REVISION NOTICE  
**Bell Helicopter****TEXTRON**  
A Subsidiary of Textron Inc.

SUBJECT: **REVISION "C" TO ALERT SERVICE BULLETIN 206-04-100 (TAIL ROTOR BLADES 206-016-201-133 / -131, CHECK/INSPECTION OF).**

Revision "C" to this bulletin introduces two WARNINGS in the COMPLIANCE section and a PART IV that provides new skin damage limits. This revision gives also the new address for RBI Inc.

NO. 206-04-100

Figure 1. Tail rotor blade inspection.

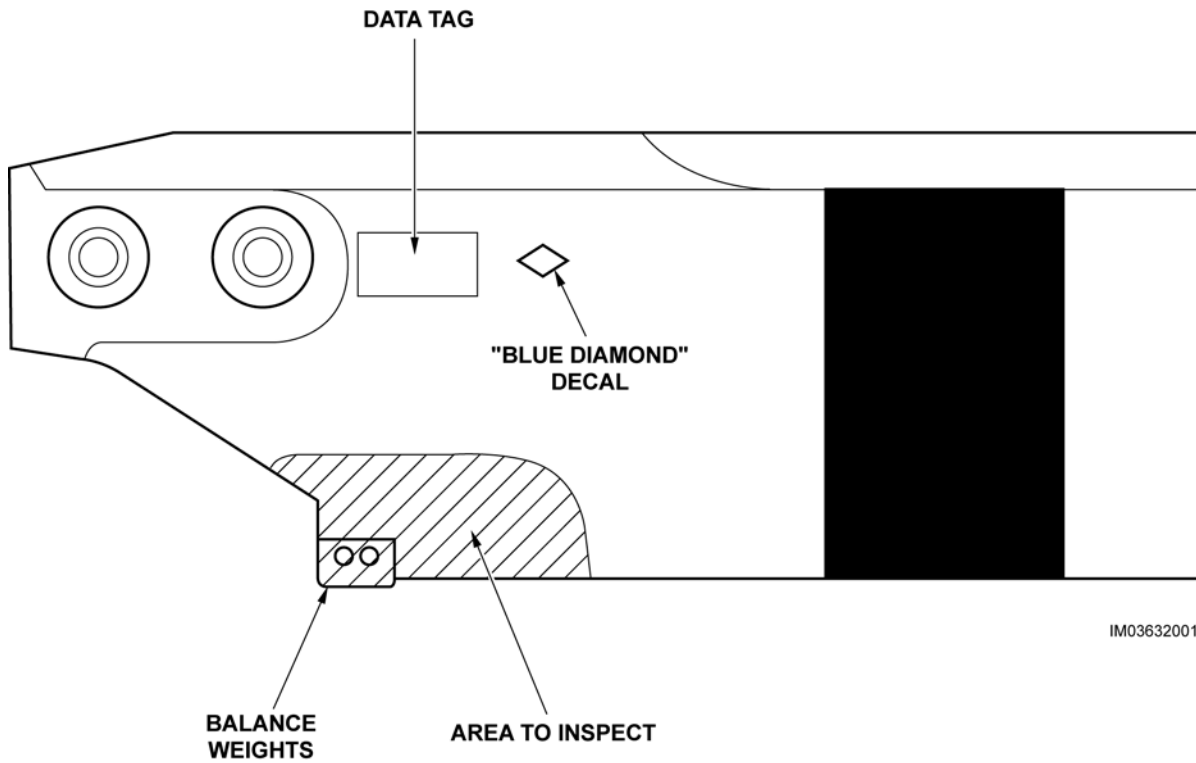
1. Use detergent (C-318) and thoroughly clean the area to be checked on both sides of the blade. Refer to Figure 1.
2. Check both sides of the blade at the area indicated on the Figure 1 as follows:
  - a. Visually check the skin for deformation or cracks.
  - b. If deformation or cracks are found, remove the blade from service.
  - c. Check the weights for bends or deformation.
  - d. If the weights are bent or deformed, remove the blade from service.
3. If no damage is found, the blade is serviceable.
4. Make log book entries to show that the PART I a. of this Alert Service Bulletin has been accomplished.

1. Use detergent (C-318) and thoroughly clean the area to be inspected on both sides of the blade. Refer to Figure 1.
2. Inspect both sides of the blade at the area indicated on the Figure 1 as follows:
  - a. Visually inspect the skin for deformation.

- b. With a 10 X power magnifying glass inspect the skin for cracks.
  - c. If skin deformation or cracks are found remove the blade from service.
  - d. Inspect the weights for bends or deformation.
  - e. If the weights are bent or deformed, remove the blade from service.
3. If no damage is found, the blade is serviceable.
  4. Make log book entries to show that the PART I b. of this Alert Service Bulletin has been accomplished.

1. Use detergent (C-318) and thoroughly clean the area to be inspected on both sides of the blade. Refer to Figure 1.
2. Inspect both sides of the blade at the area indicated on the Figure 1 as follows:

- a. Visually inspect the skin for deformation.
  - b. With a 10 X power magnifying glass inspect the skin for cracks.
  - c. If skin deformation or cracks are found remove the blade from service.

- d. Inspect the weights for bends or deformation.
  - e. If the weights are bent or deformed, remove the blade from service.
3. If no damage is found, the blade is serviceable.

4. In order to provide a quick visual reference and identify the blades affected by this ASB, apply the "blue diamond" decal provided with this ASB on both sides of the blade at the location indicated on the Figure 1. To prolong the life of the decal, apply Edge sealer on the decal. Replace missing or damaged decal as required.
